Access Compliance Report

Public Rights-of-Way

(Curb Ramps)

Intersection ID: 48196	Main Street: BLAKENEY_PARK_DR	Cross Street: REA_RD	Location: SE
ADA ID: 16B477BC62D7	Ramp Type: PerpDiag	Initial Pass/Fail: Fail	Overall Compliance: No
Codes/Mitigation Info/Possible Solution			Severity Score: 35
			Field Measurements/Component Compliance

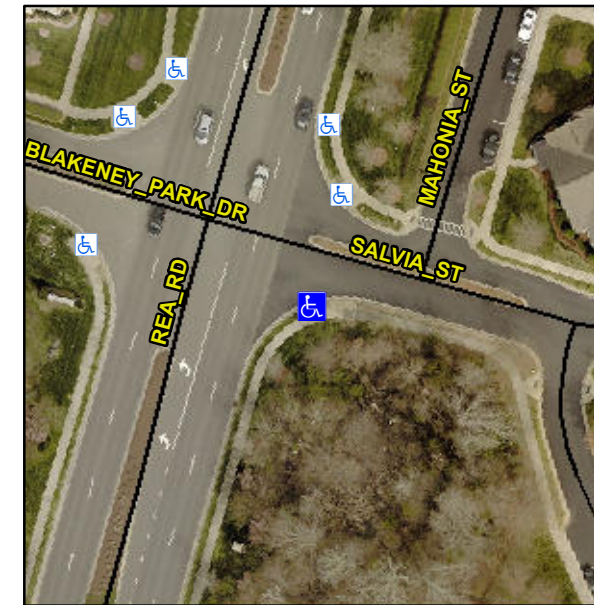
Not Found, R304.5.1, R304.2.2, R304.5.3

Compliance	Description	Data	Compliance	Description	Data
N/A	Ramp Length (in)	45.0	No	Ramp Slope (%)	12.6
No	Ramp Width (in)	46.0	No	Ramp XSlope (%)	2.5
N/A	Flare Type LT	N/A	N/A	Flare Type RT	N/A
N/A	Flare Slope LT (%)	N/A	N/A	Flare Slope RT (%)	N/A
N/A	Flare Traversable LT?	N/A	N/A	Flare Traversable RT?	N/A
N/A	Landing Length (in)	N/A	N/A	DWS Provided?	N/A
N/A	Landing Width (in)	N/A	N/A	DWS Contrast?	N/A
N/A	Landing Slope (%)	N/A	N/A	DWS Length (in)	N/A
N/A	Landing X Slope (%)	N/A	N/A	DWS Full Width?	N/A
N/A	Landing Curb? (Y/N)	N/A	N/A	DWS Offset (in)	N/A
N/A	Shared Landing?	N/A			
N/A	Gutter Ponding?	N/A	N/A	Gutter Slope (%)	N/A
N/A	Gutter Lip Ht (in)	N/A	N/A	Gutter X Slope (%)	N/A
N/A	Painted X Walk1?	No	N/A	Painted X Walk2?	No
	X Walk 1 Direction	To NE		X Walk 2 Direction	To NW
N/A	X Walk 1 Width (in)	N/A	N/A	X Walk 2 Width (in)	N/A
	X Walk 1 Slope (%)	0.4		X Walk 2 Slope (%)	4.2
	X Walk 1 X Slope (%)	3.3		X Walk 2 X Slope (%)	1.4

Remove & Replace Curb Ramp With Two New Directional Ramps or Equivalent.
